NUREG-0800

APPENDIX 7.0-A REVIEW PROCESS FOR DIGITAL INSTRUMENTATION AND

Draft Revision 6 – August 2015

CONTROL SYSTEMS

Figure 7.0-A-5. Software life-cycle activities.

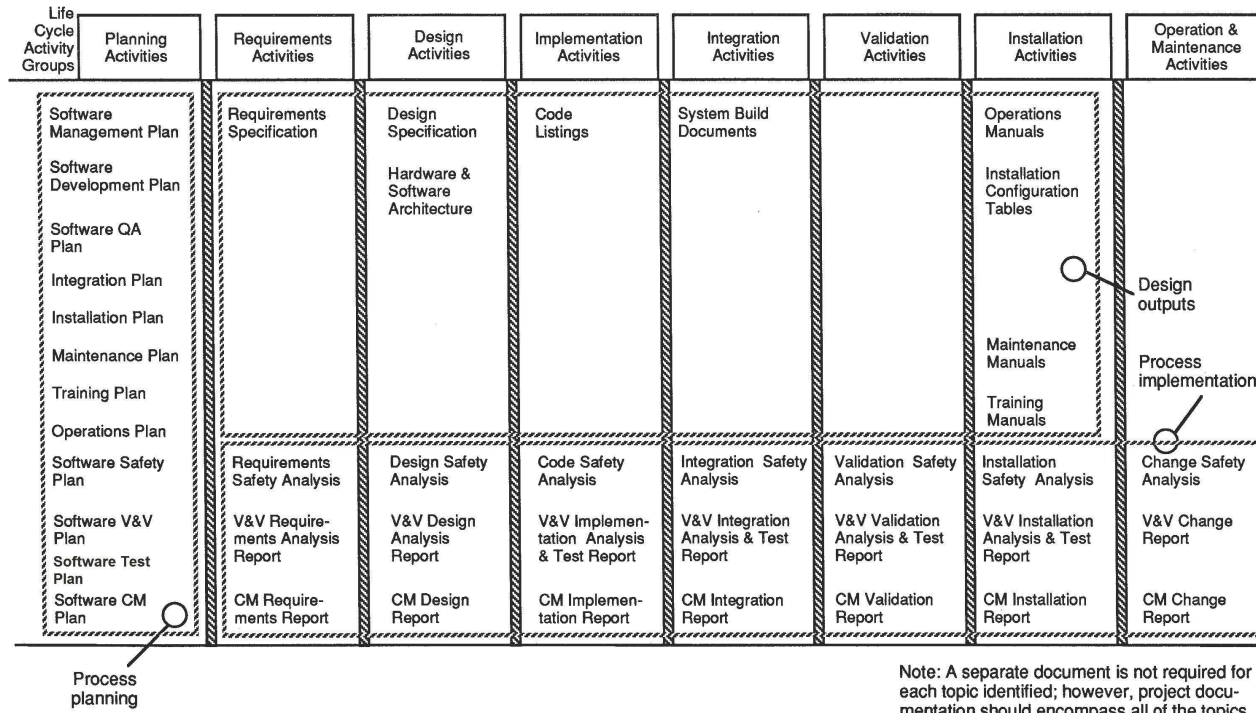
Additional guidance has been provided for the use of ITAAC in the review of software life-cycle activities. Figure 7.0-A-5 was revised to add the Software Test Plan under Planning Activities.
